SUBJECT: Forwards response to NRC 920228 request for addl info re emergency power sys enhancement project, consisting of discussion of swing bus transfer scheme implemented at facilities & set of logic diagrams.

Re: Turkey Point Units 3 and 4
Docket No. 50-250 and 50-251
TAC Nos. M82839 and M82840
Response to Request for Additional Information

Load Center 3H Simplified Single Line Diagram

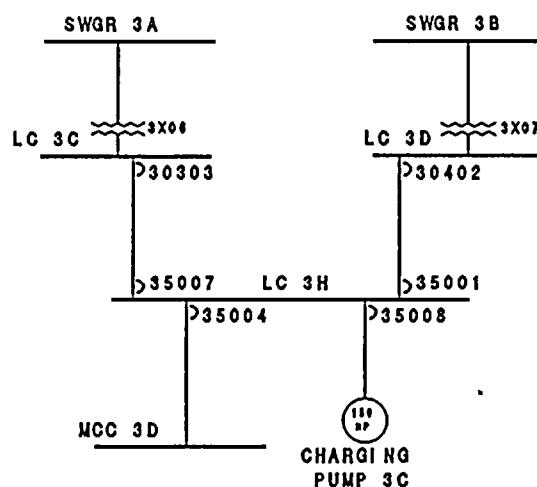
The NRC's Request for Additional Information (RAI) stated that the swing buses (3H and 4H) could be utilized to tie the redundant trains together in the event an emergency diesel generator is not available. The swing

load centers are not intended to be utilized to tie redundant buses together and the load center bus tie-breakers are interlocked to prevent such occurrence. The RAI also expressed concern that an automatic transfer capability between redundant emergency buses could compromise the independence of redundant power sources and that the scheme may be vulnerable to a single failure. The RAI also requested additional information for three areas of design for the swing load centers. These specific areas are addressed below:

The following description provides further information of the design and operation of Load Center 3H for Turkey Point Unit No 3. The description is also applicable to Unit No 4, since the design for Load Center 4H is similar to that of Load Center 3H.

The Emergency Containment Cooler (ECC) and Emergency Containment Filter (ECF) systems at Turkey Point Unit 3 consist of three units. One is powered by Train A, one is powered by Train B, and one is powered by Load Center 3H via MCC 3D. The FSAR accident analysis requires a minimum of two ECCs and two ECFs to respond to a Safety Injection (SI) signal.

The 480 volt AC Emergency Power System consists of five load centers (LCs). Load Centers 3A and 3C are fed from 4160 volt Switchgear 3A (Train A). Load Centers 3B and 3D are fed from 4160 volt Switchgear 3B (Train B). Swing Load Center 3H can be powered by either Train A or Train B through Load Centers 3C or 3D, respectively. Load Center 3H has been designed as a voltage seeking, dead transfer swing bus in order to ensure that a minimum of two ECCs and two ECFs will be available in the event of a single train failure.

Load Center 3H is intertied to Load Center 3C (Train A) via two tie-breakers (30303 and 35007) and to Load Center 3D (Train B) via two tie-breakers (30402 and 35001) as shown above. Load Center 3H feeder breakers, 30402 and 30303, act as slave breakers to incoming breakers 35001 and 35007. The feeder breaker from Train A is located on Load Center 3C and the feeder breaker from Train B is located on Load Center 3D. The incoming breakers are located on Load Center 3H.

The voltage seeking, dead transfer scheme allows the load center on Loss of Offsite Power (LOOP) or on LOOP with concurrent Loss of Coolant Accident (LOCA) to retain its selected alignment and to re-energize upon power return 16.5 seconds after the event, (1 second for LOOP detection, 15 seconds to reach EDG rated frequency and voltage and close EDG breaker, and 0.5 seconds to operate the first load block and energize the load centers) or to transfer if the selected alignment train fails to re-energize. The Logic Diagrams for the tie breakers associated with Load Center 3H are provided in Attachment 2 (Unit 4 is similar).
